UNITED STATES PATENT AND TRADEMARK OFFICE

APPLICATION NO.	FILING DATE	FIRST NAMED INVENTOR	ATTORNEY DOCKET NO.	CONFIRMATION NO.
10/820,401	04/08/2004	Stylios Panaghe	7579	8464

Office Action Summary	Application No. 10/820,401	Applicant(s) PANAGHE, STYLIANOS	
	Examiner John A. Jeffery	Art Unit 3742

DETAILED ACTION

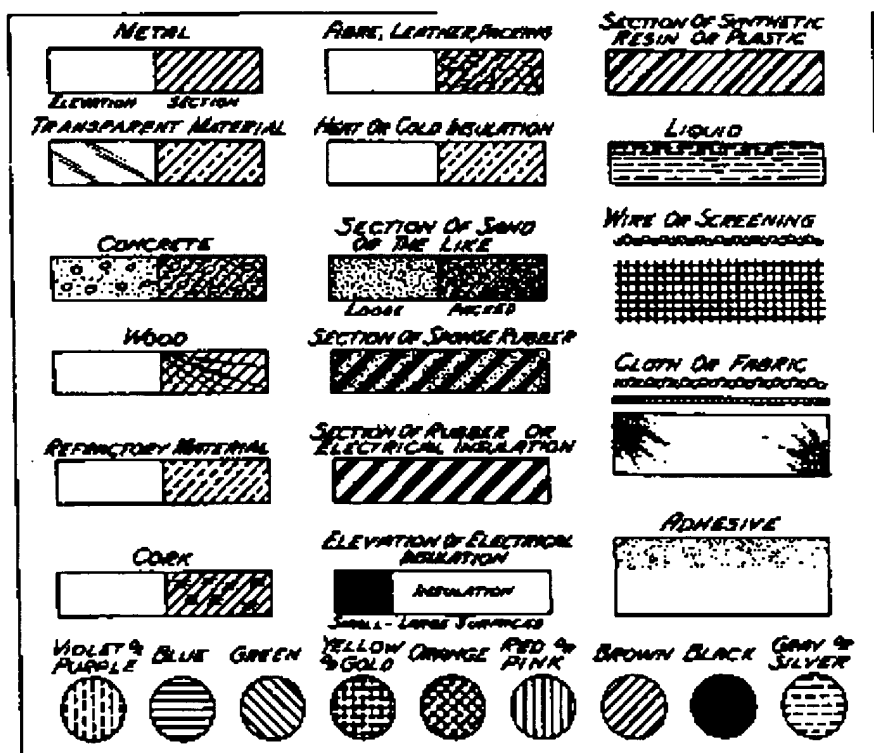
Fig. 1 and 2: Proper cross-sectional hatching is required to properly denote insulative materials for (1) ceramic tracks 3 and 4, and (2) dielectric layer 6 in accordance with MPEP 608.02 (see the drawing below for proper hatching examples). The layers are currently incorrectly hatched for metal.

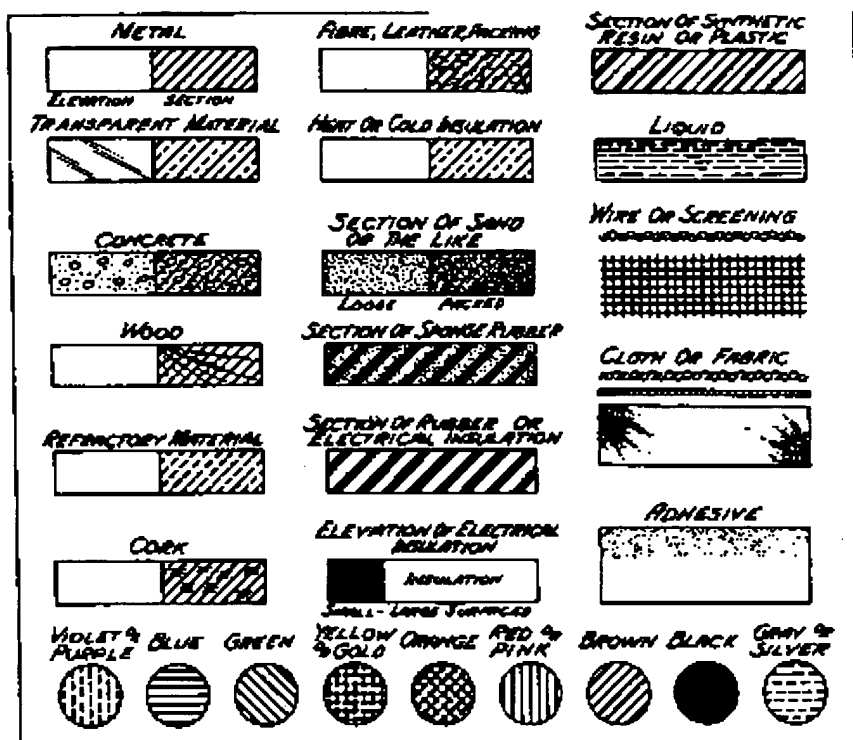
Applicant must also enlarge Fig. 2 for clarity so that proper hatching is legible within each layer's thickness.
